MEMORANDUM

From:	Tina Cuss Ecology Officer		
Service	WBC Ecology	App No:	260967
Address:	Billingbear Lodge, Maidenhead Road, Binfield, Wokingham, RG40 5RU.		
Proposal:	Application for submission of details to comply with the following conditions of planning consent 253011 dated 04/03/2026. Condition 5 relates to tree protection, 6 to landscaping and 7 to a bat licence.		
Type of Development:			
Site Visit Made:	No

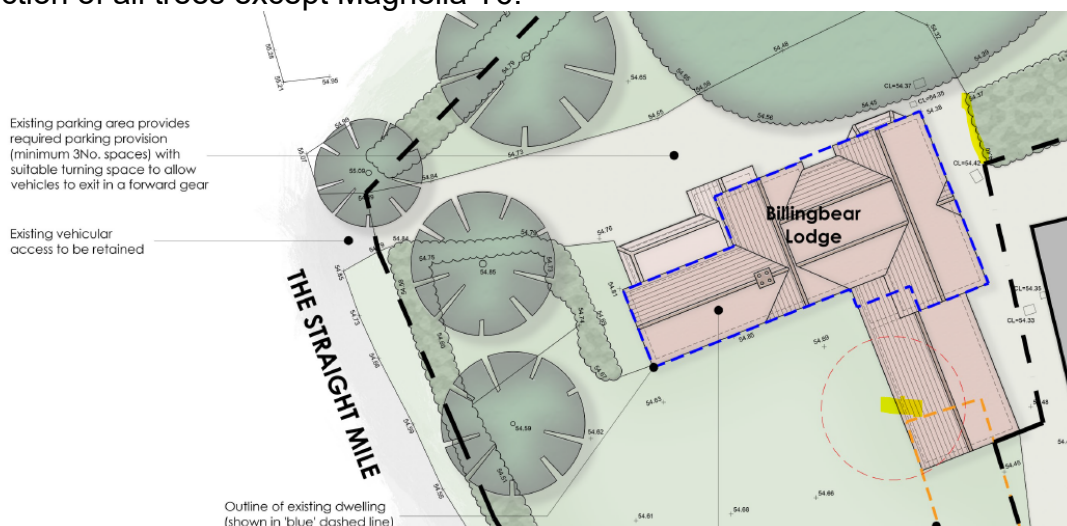
Tree Protection Plan TPP KG2 does not protect the retained Acacia T3, Douglas Fir T4 and hedgerow round the north and west of T4 and is inconsistent with the Landscape Plan P25-18-S-290 and with the approved Site Layout & Roof Plan (P25-18-S-201 RevA 3 March 2026) approved in 263011 conditon 2. In order to maintain favourable conservation status for bats and protect and enhance features for wildlife the Tree Protection Plan and Arboricultural Method Statement should be revised to show protection of both Acacia trees and retained T4 and the hedgerow and that demonstrate that only T6 will be removed and works to hedges are limited to only minimal pruning works to the eastern hedgerow.

In order to recommend approval of a landscaping scheme the proposals must be amended to include retention of the hedgerow around T4 and retention and protection of all trees except Magnolia T6.

I recommend the submitted plans are not approved and conditions 5 and 6 are not discharged. The landscaping and tree protection scheme must be amended to show retention and permanent of all the landscape features shown as retained in Site Layout & Roof Plan 201 RevA.
